PRELIMINARY CERTIFICATE OF APPROPRIATENESS
CLIFTON ARCHITECTURAL REVIEW BOARD
TOWN OF CLIFTON, VIRGINIA
APPLICATION FOR CERTIFICATE OF APPROPRIATENESS

DATE OF APPLICATION: 9/15/20
NAME OF APPLICANT OR AGENT: DAVID GUGLIELMI
ADDRESS: 10918 WOODFAIR RD, FAIRFAX STATION, VA 22039
TELEPHONE: 703 623 4343 email dguglielmi@yahoo.com
LOCATION OF PROPERTY INCLUDING STREET ADDRESS AND TAX MAP NUMBER: 7184 CLIFTON ROAD TAX MAP
GENERAL DESCRIPTION OF PROPOSAL:
MODIFICATIONS REQUESTED TO APPROVED DESIGN / AMENDED COA. DETAILED NARRATIVE INCLUDED ON SEPARATE PAGES.

The following ten (10) conditions are required as part of the Preliminary COA as a result of the September 24, 2020 meeting and should remain permanently attached to the Preliminary COA:

Front Porch and Rear Areaway Rail Detail-
Wood painted flat white

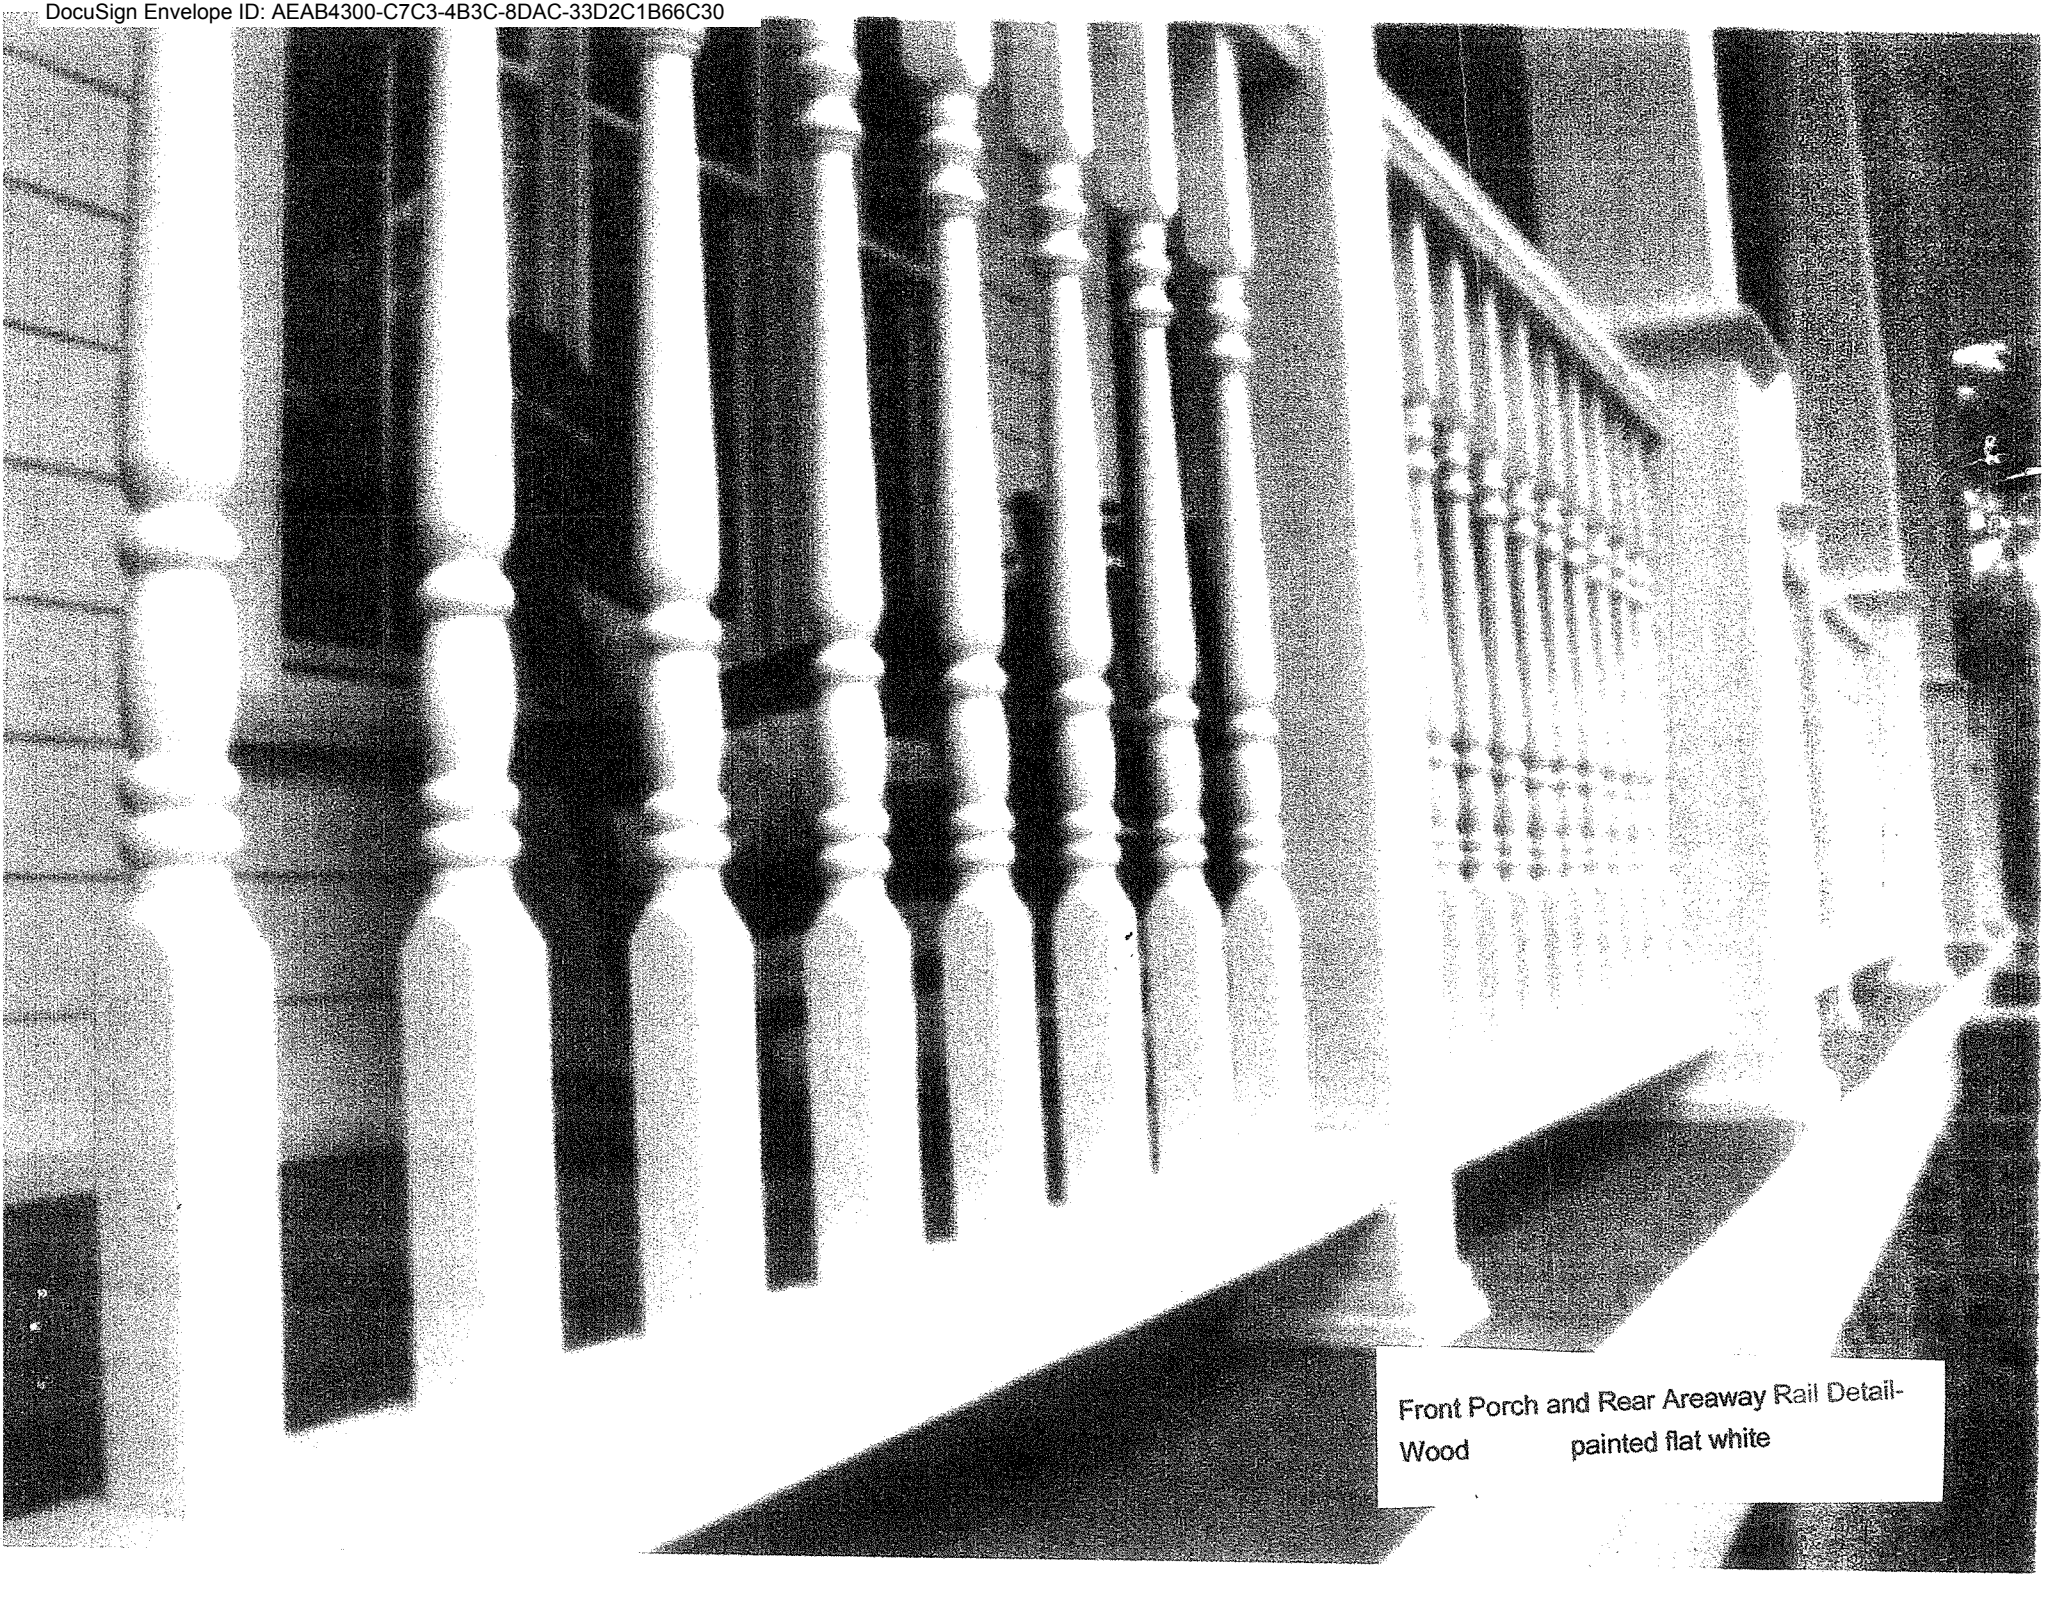
3. Porch railing.
The ARB has accepted Mr. Guglielmi's proposal to remove the vinyl railing system and to replace with wooden posts and railing to be painted white as per the original COA (photo of re-approved wooden post/railing system attached).

TYPICAL ARCHITECTURAL ELEMENTS

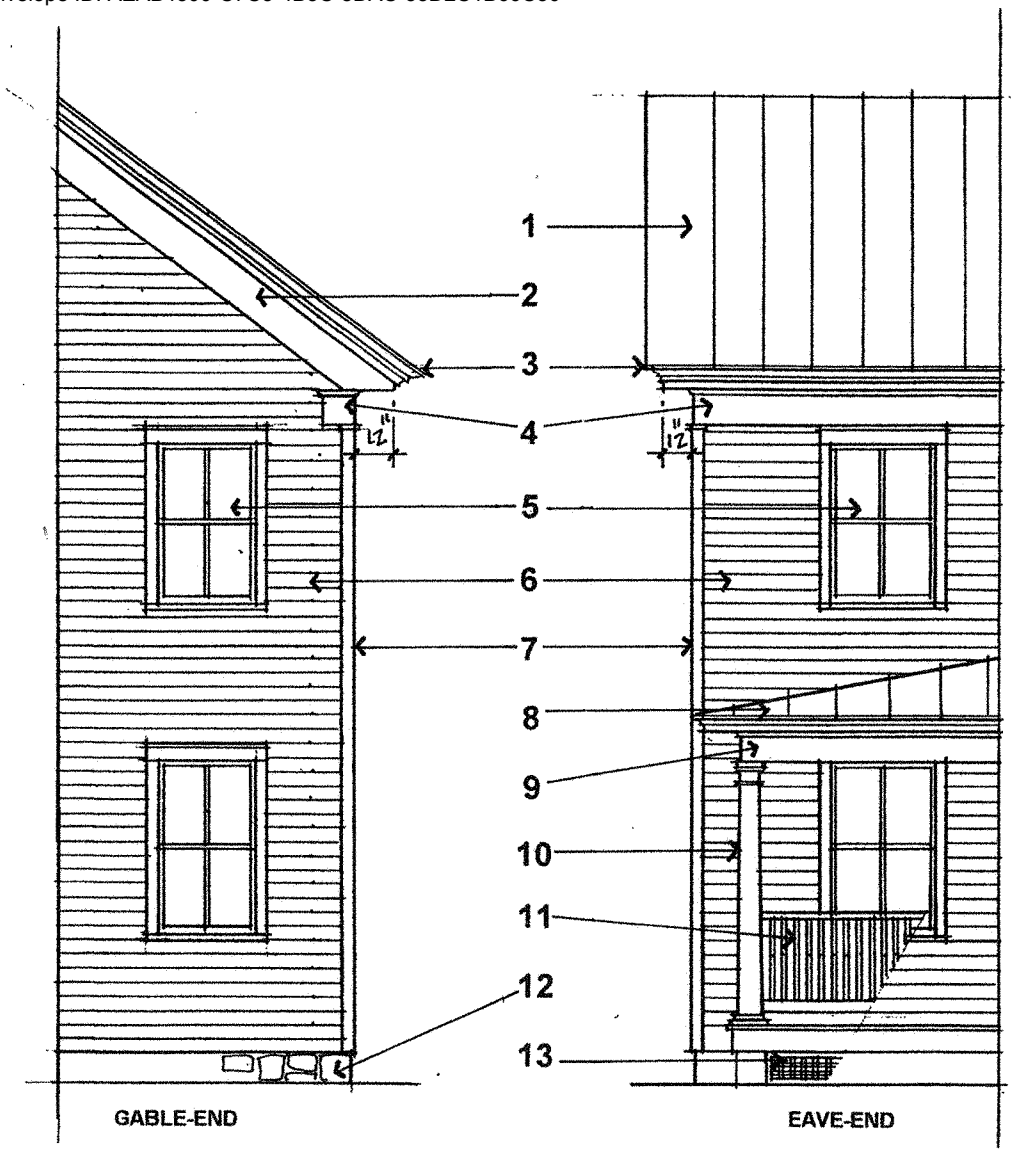
7. Eve returns and rake trim.
Mr. Guglielmi has agreed to modify the six (6) box returns to comply with the originally-approved frieze-board return style by removing and replacing the trim (photo attached of non-compliant return and original style approved).

PROPOSED FRONT ELEVATION

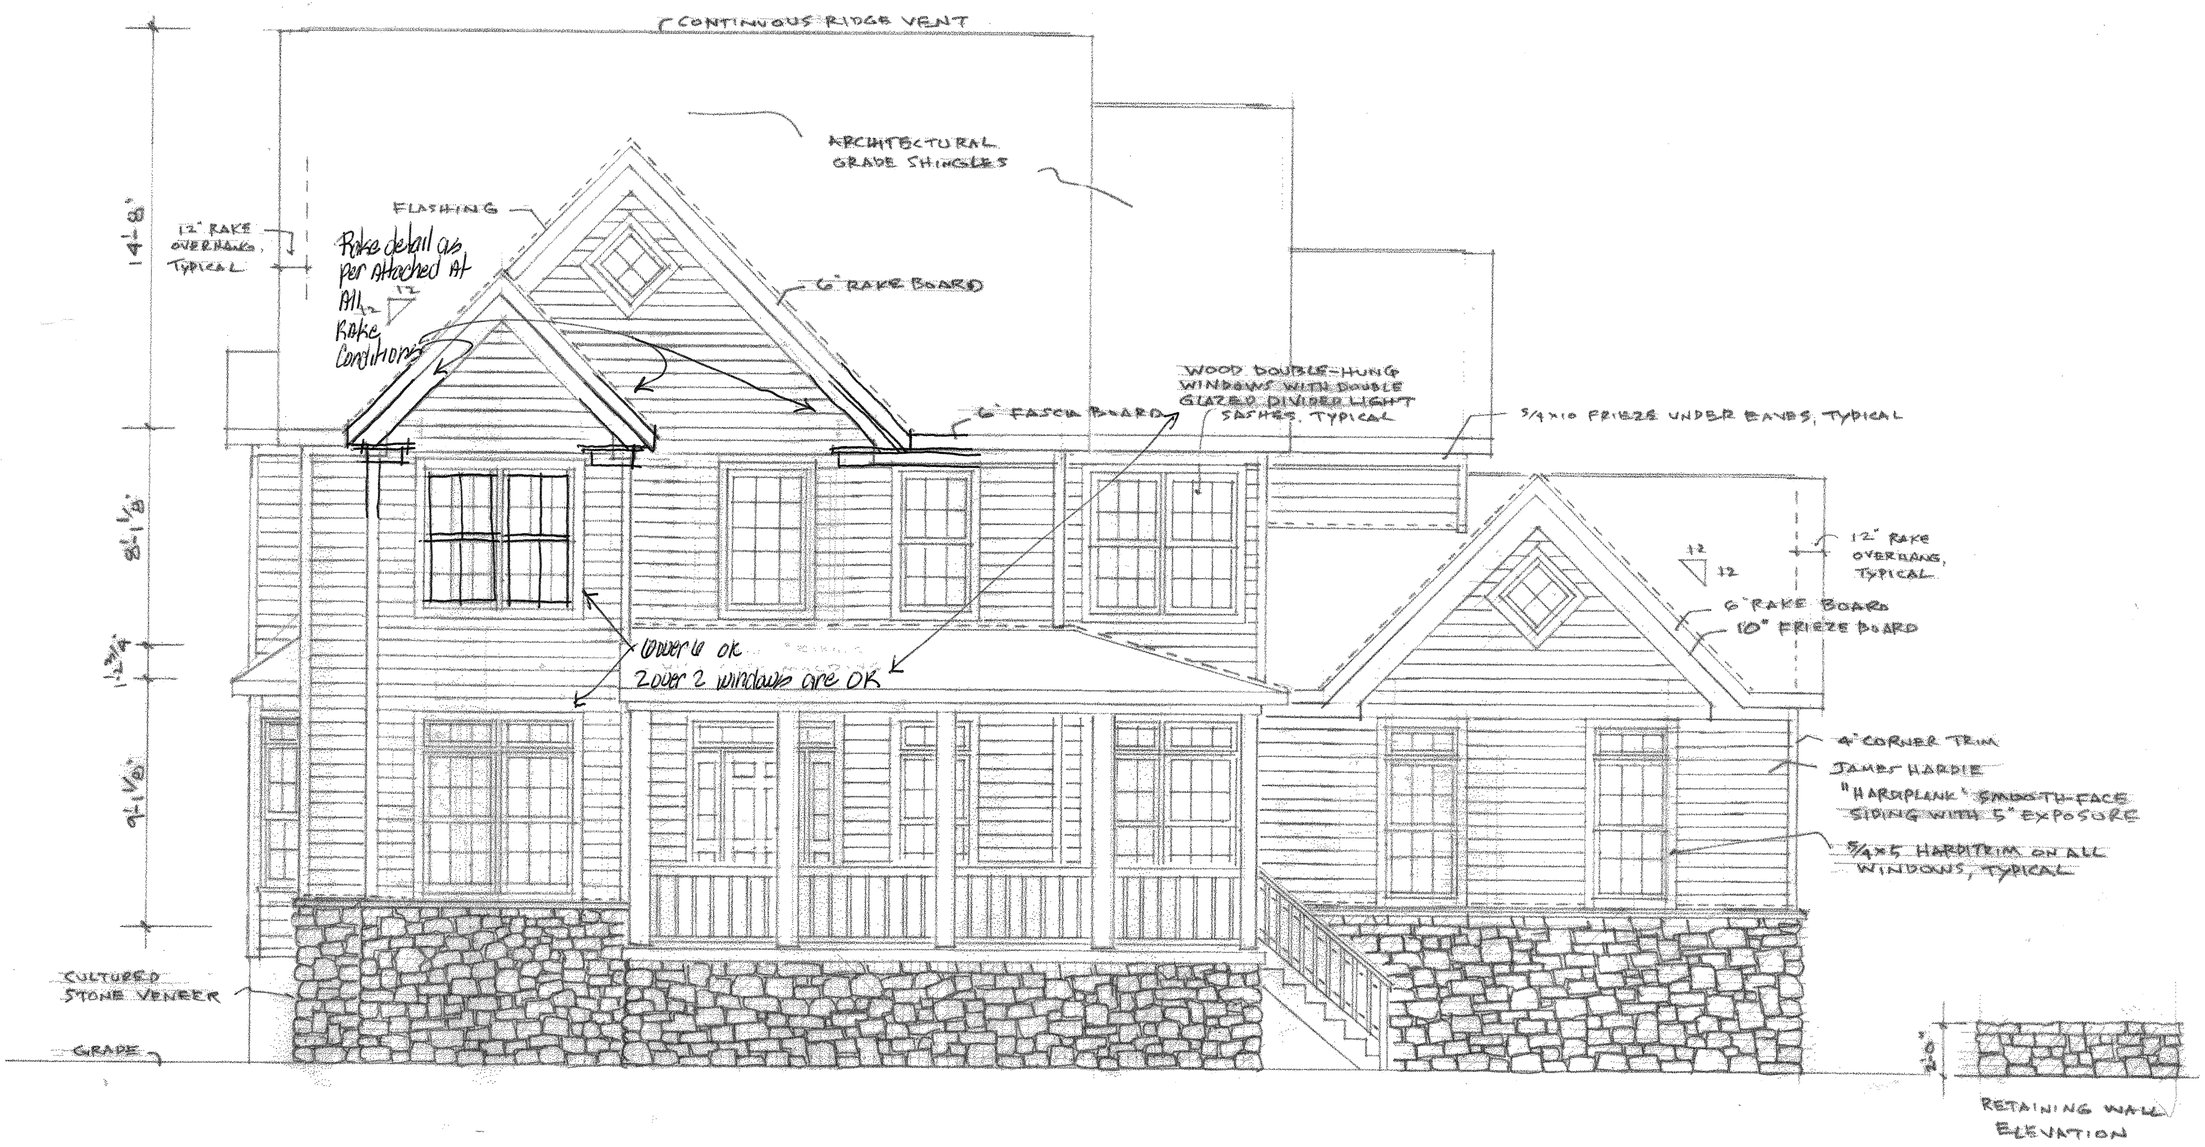
Required rake trim detailed shown on this page

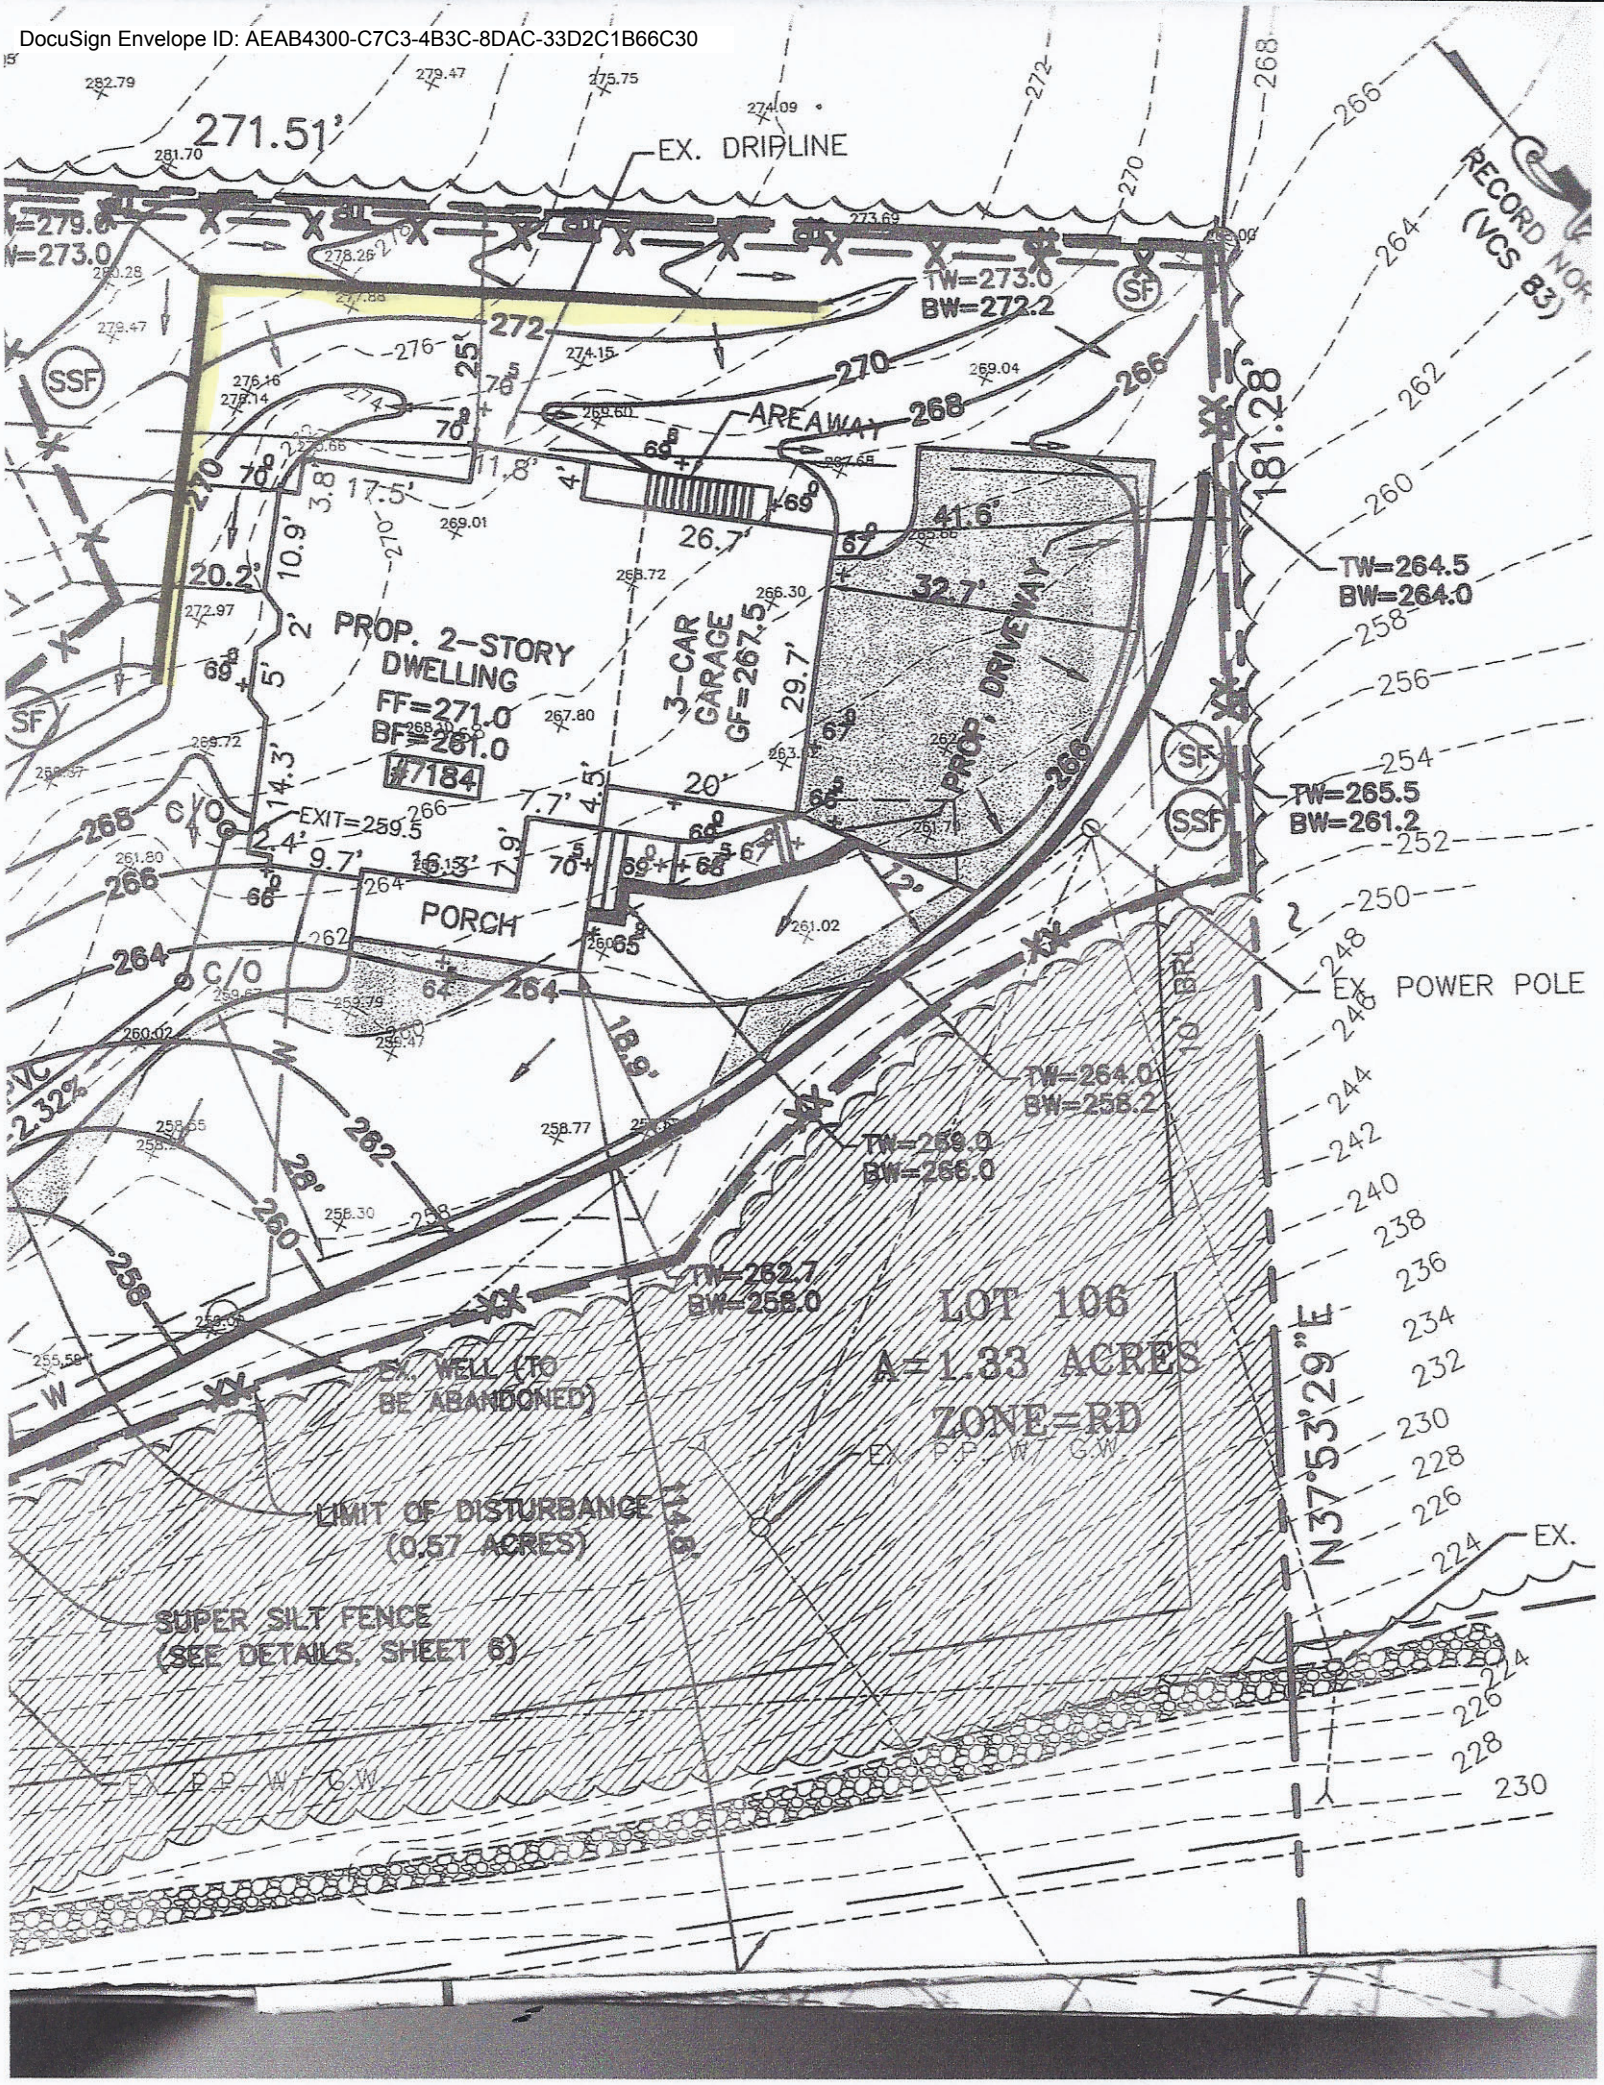
I propose to construct a soldier pile wood retaining wall from 6 inches in height up to 6 feet in height in the rear of the property. The topography of my site, as well as the location of the house, will prevent the retaining wall from being visible from the road or any public space. The State Building Code mandates a handrail for any section of the wall that is greater than 30 inches. Thus, I also propose to install a black metal hand rail at the top of the wall where required.

CONDITIONS: APPROVAL IS FOR REAR WALL ONLY

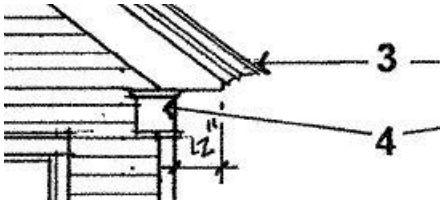
7. The “dog-eared” eve returns were not approved. Mr. Guglielmi has agreed to modify all non-conforming box returns to match the frieze-board molding returns as detailed below.

Compared to frieze-board molding returns as submitted and approved by the ARB:
